HOLLY TREE FARM
BROOKGATE WESTON

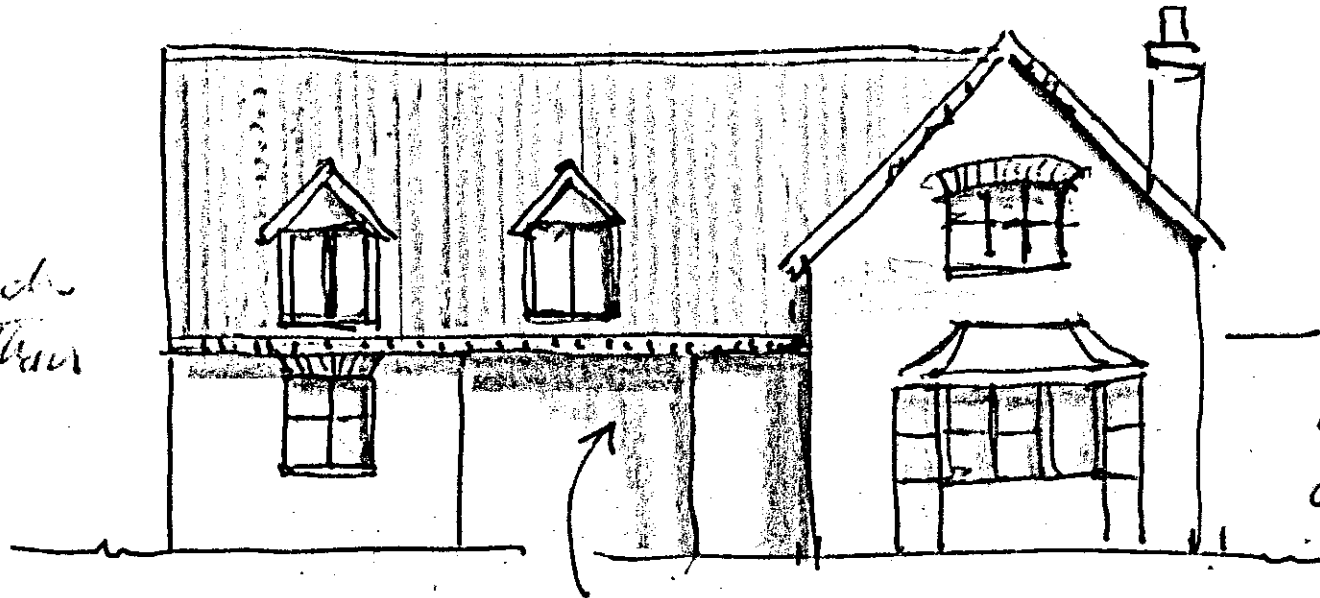
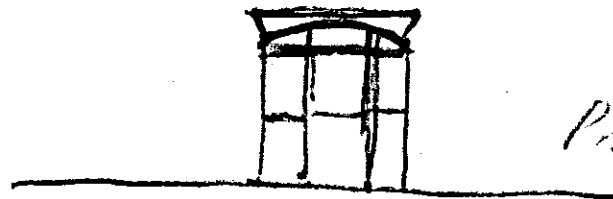
Clay pantile

To make the
bay distinctive
carry it down
in brick

Flat arch
rather than
soldiers

Client wished
to reduce width
of lounge

Suggest reducing
width of dormers
and placing them
near the eaves
(May have over-done
this)

I don't think the detail of
this opening works with courses of brick
'hanging' in the
air

Probably needs to be
narrower.

Have drawn this slightly too low
should sit under dentils
